AR877-RPTA Ramp Relay Conversion

"DOCUMENT UNCONTROLLED IF PRINTED"						
DOC #	PROCESS NAME	PAGE	REVISION	STATION	BY	DATE
AR877	RPTA Ramp Relay Conversion	1	-	SERVICE-E	Brad Fisher	10/7/20

Complaint: 24v Feedback to IO module from ramp

CON-C (GREEN)
FEP, Center

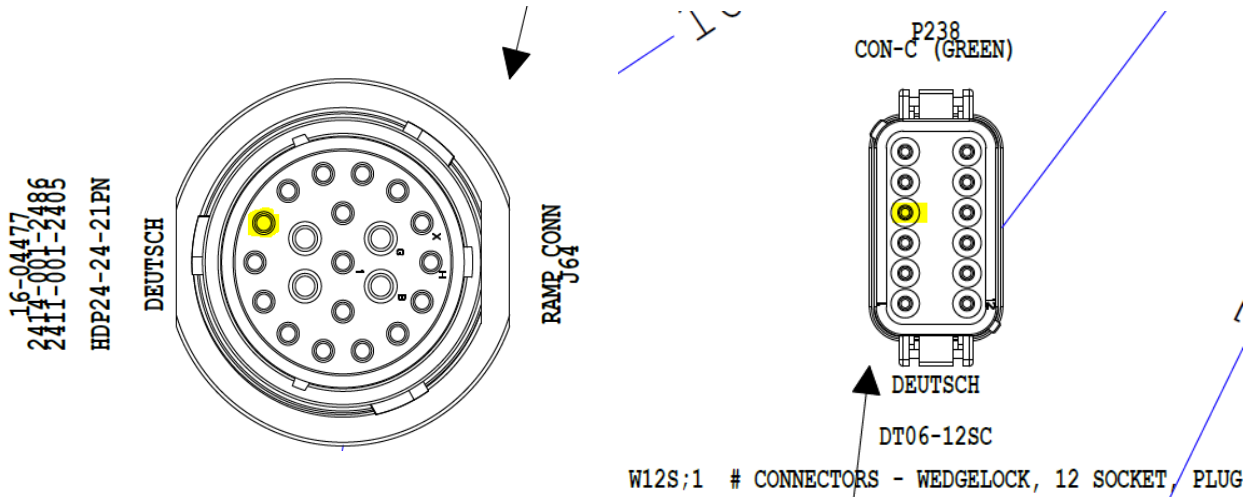
Cause : 24v Ramp system was not converted to 12v signal to IO.

Correction: Install Relay Harness

- 1: Remove black wire from green IO connector position # 4 - In front electrical panel and cut off terminal.
- 2: Connect black wire in new harness to black wire removed in step 1 and splice these 2 wires together.
- 3: Install orange wire from new harness into green IO connector position # 4
- 4: Connect black wire with ring terminal onto ground bar.
- 5: Connect red wire in new harness onto existing circuit breaker - see photo - arrow.
- 6: Mount relays in space above ground bar - see photo X- and secure wires properly in front electrical panel.
